**CITY OF MANHATTAN BEACH  
DEPARTMENT OF COMMUNITY DEVELOPMENT**

**SUBJECT:** Consideration of an Encroachment Permit Appeal to Allow a Water Fountain Feature in the Public Right-of-Way to Remain – 130 41st Street

# FRONT YARD WATER FEATURE - 130 41st STREET

## POST-CONSTRUCTION ENCROACHMENT PERMIT APPLICATION SUBMITTAL

**1 SITE PLAN**  
 SCALE: 1/4" = 1'-0"

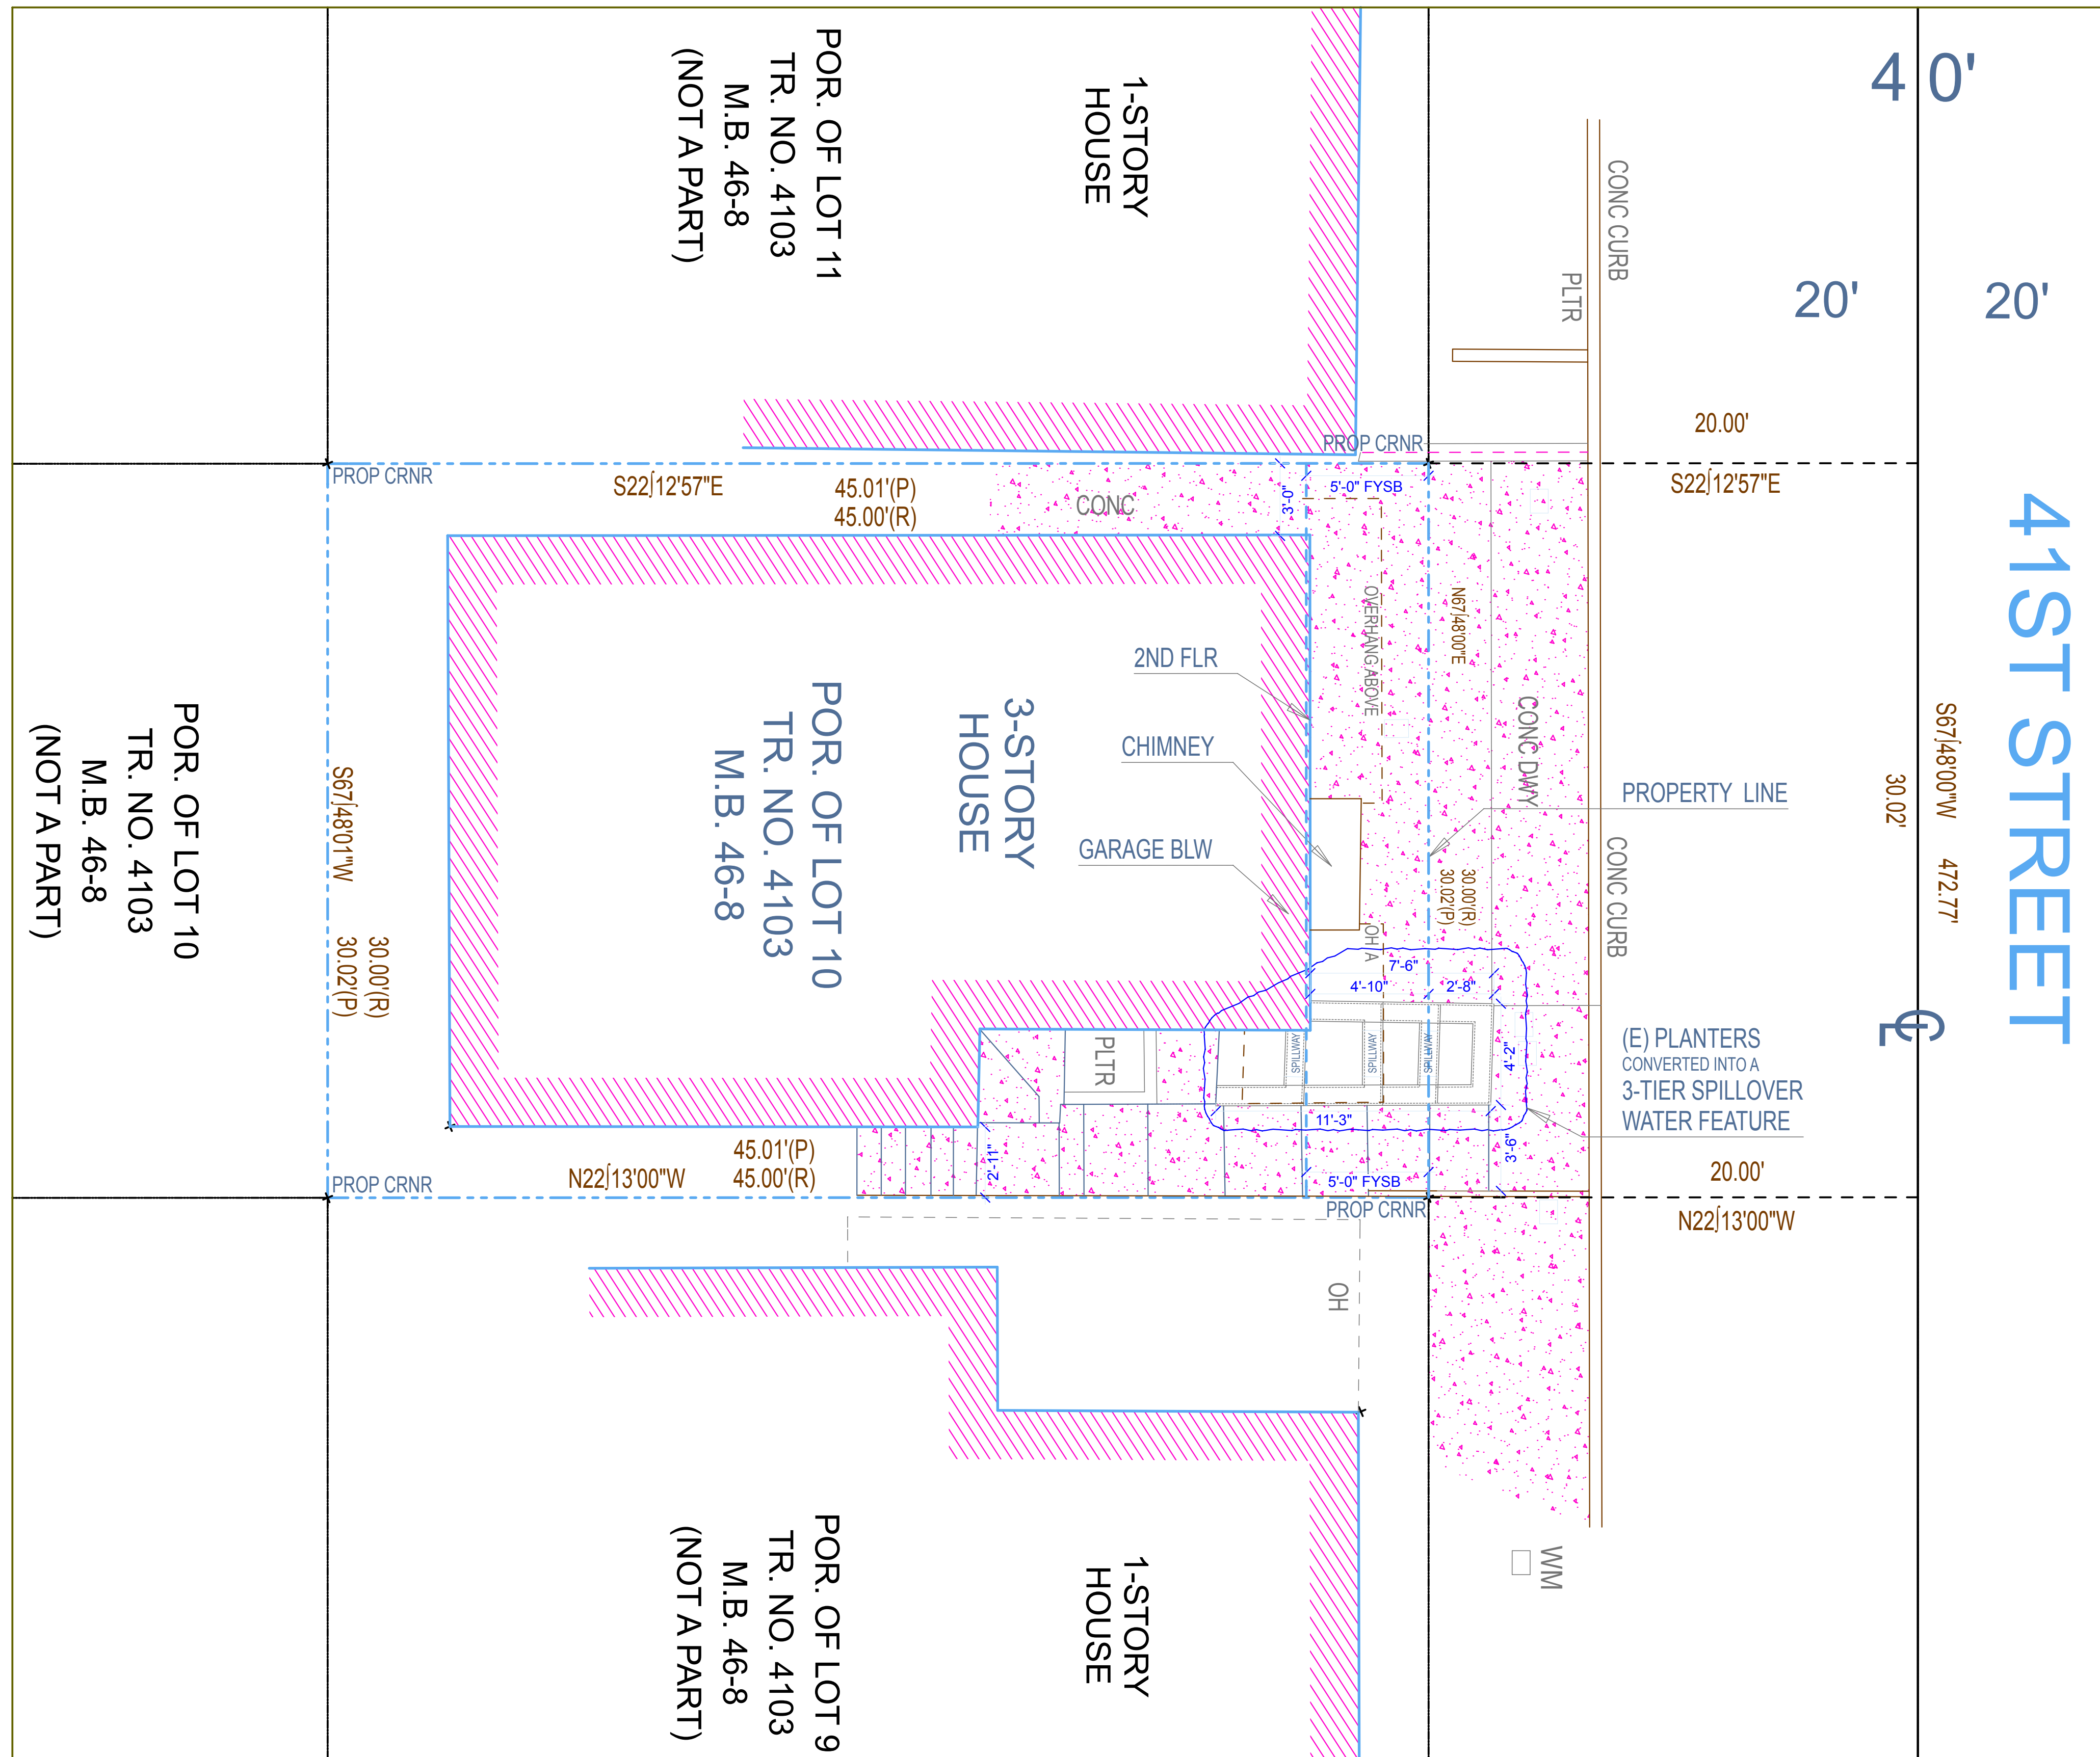
A building permit was issued for an interior remodel on the subject property on August 9, 2012, without any proposed exterior or encroachment work. After construction the applicant altered the existing planter/retaining wall creating a water fountain feature in the private front yard and into the public right-of-way, which is not permitted. Subsequently, Code Enforcement contacted the applicant regarding filing an encroachment permit application to request approval for the improvements. Upon submitting the Encroachment Permit, Planning Department staff informed the applicant that such improvements cannot be permitted by staff. Thereafter the applicant submitted an Encroachment Permit appeal on October 2, 2013. In accordance with Section 7.36.080 of Manhattan Beach Municipal Code, the Parking and Public Improvements Commission (PPIC) must review the appeal request and forward its recommendation to the City Council. The first 2.5 feet of the water fountain feature is located in the public right-of-way, the remaining 4 feet is located on private property.

The submitted appeal plan shows modifications to the existing planter wall, creating a water fountain feature extending into the site's existing sloped encroachment area. Section 7.36.150 (D) of the Municipal Code permits fences and walls in encroachment areas at a maximum height of 36 inches in this area, but does not permit water fountain features or other improvements in drive-street encroachment areas. The plan does provide the required 2-foot clearance from the street improvements, and since there are no sidewalks in this area, this distance is measured from the back edge of the curb to the existing wall. The house was originally built in 1986 and the planter was approved at that time.

The Municipal Code Section 7.36.150 (D) states that only fences and walls up to 36" and landscaping are permitted on vehicular streets. Staff's understanding of the purpose of this requirement is to allow minimal private use of the public right-of-way with minor improvements and limited alteration of the natural grade. Raising the natural grade with retaining walls or planters is not currently allowed per code. Since the planter previously existed, it may remain. However, the water fountain feature intensifies the non-conforming condition, and may create a potential liability for the City due to accidental run-off on the adjacent street and driveways, and the presence as potentially an attractive nuisance.

Staff does not support the request for the water fountain feature because it is not consistent with the encroachment standards described above, and staff recommends that the PPIC recommend denial of the Encroachment Permit Appeal request to the City Council.

Staff recommends that the Commission **DENY** the request at 130 41st Street to permit a water fountain feature in the 41st Street public right of way (drive-street).
